**TOWN OF ERIE
BOARD OF TRUSTEES
August 27, 2019**

SUBJECT: **Agenda # 19-371**

Review of Colliers Hill Filing No. 4G Sketch Plan

PURPOSE: Review and comment on a Sketch Plan application for 201 single-family detached units.

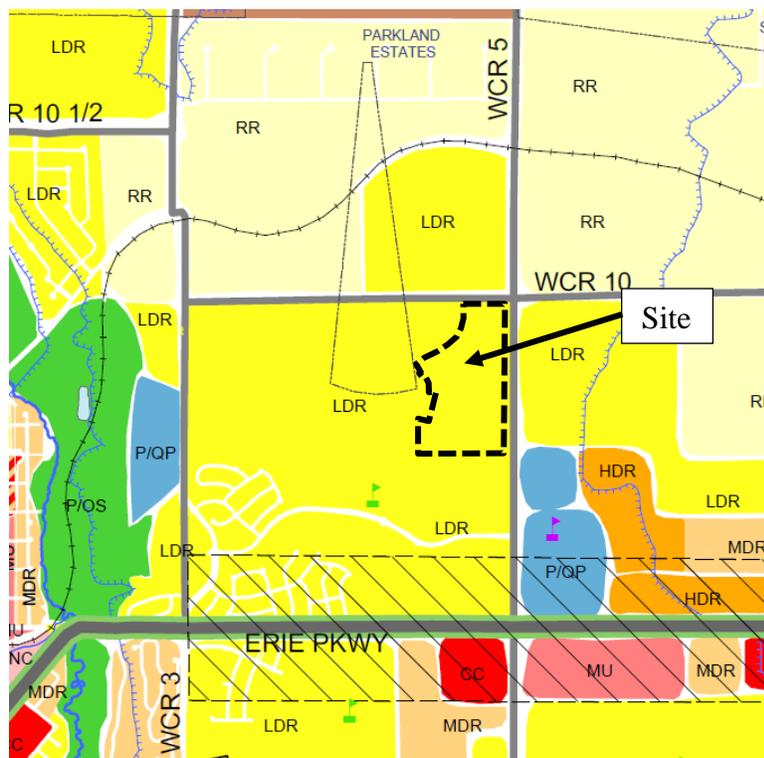
A Pocket park is required per the UDC and PUD and is depicted on the Sketch Plan. Pocket parks shall comply with all Town Standards and Specifications. All parks and amenity areas will be accessible to the residents via trail linkages and block crossings. Pedestrian areas will tie into the larger open space and trails network with the overall Colliers Hill Development.

The Parks Department stated concerns with the lack of on street parking contiguous to the neighborhood park. Parks also requested the lots on the east of the park to be removed. Further discussions will be required prior to Preliminary Plat.

Future plan submittals should illustrate how parks and trails connections are being made to the existing and proposed trail and park infrastructure. The Parks Division has provided the applicant with comments.

Compliance with the PUD Map

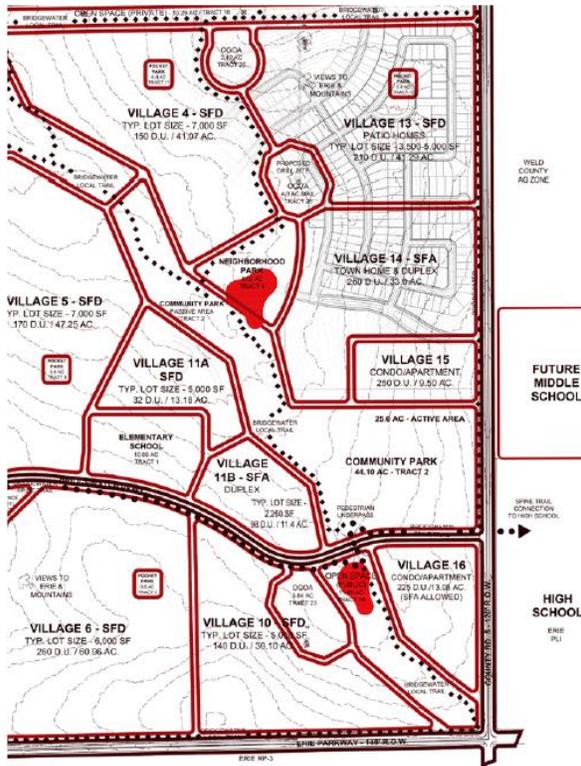
The proposed Sketch Plan is inconsistent with the existing PUD. Because of the applicant’s proposed Sketch Plan, an amendment to the PUD to allow the project is required.

The Sketch plan proposes to change land uses by:

- Expanding standard Single-Family Detached lots of 5,000 square feet or more by 51.5 acres, which would allow up to 210 dwelling units. This expansion would combine Villages 13 and 14.
- Eliminating Village 13 consisting of 210 patio homes (3,500 to 5,000 square foot lots) on 41.29 acres.
- Eliminating Village 14 consisting of 33 acres with 260 units of townhomes and duplexes.
- Change Village 15 from 9.5 acres with 250 dwelling units of apartment only dwellings to 14.76 with 250 units of single-family attached (townhomes or multi-family apartments).
- Change Village 16 from 13 acres with 225 apartment only dwelling units to 13 acres with 225 single-family attached and/or multi-family.

The proposed amendment significantly reduces the land area dedicated to alternative housing types.

Sketch Plan & Bridgewater P.U.D. Amendment 4 Overlay

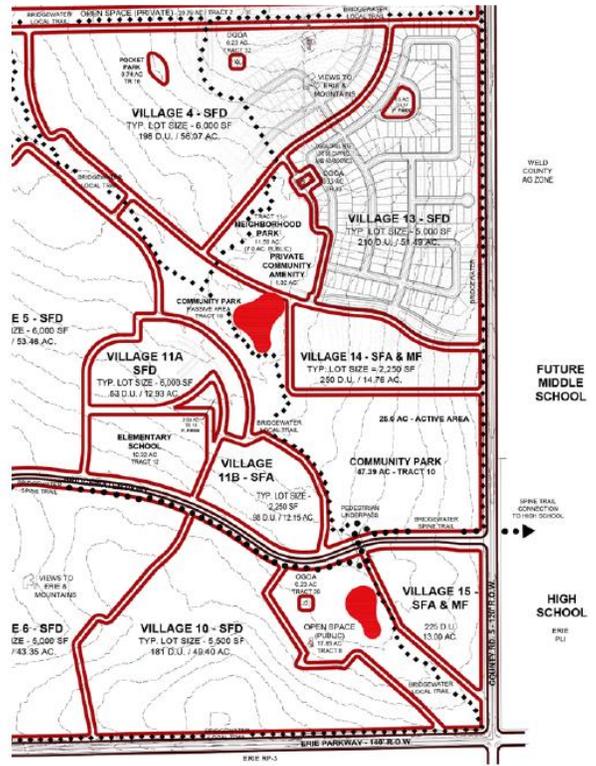
Below are the proposed changes to the PUD. The existing PUD is on the left and the proposed amendment is on the right.
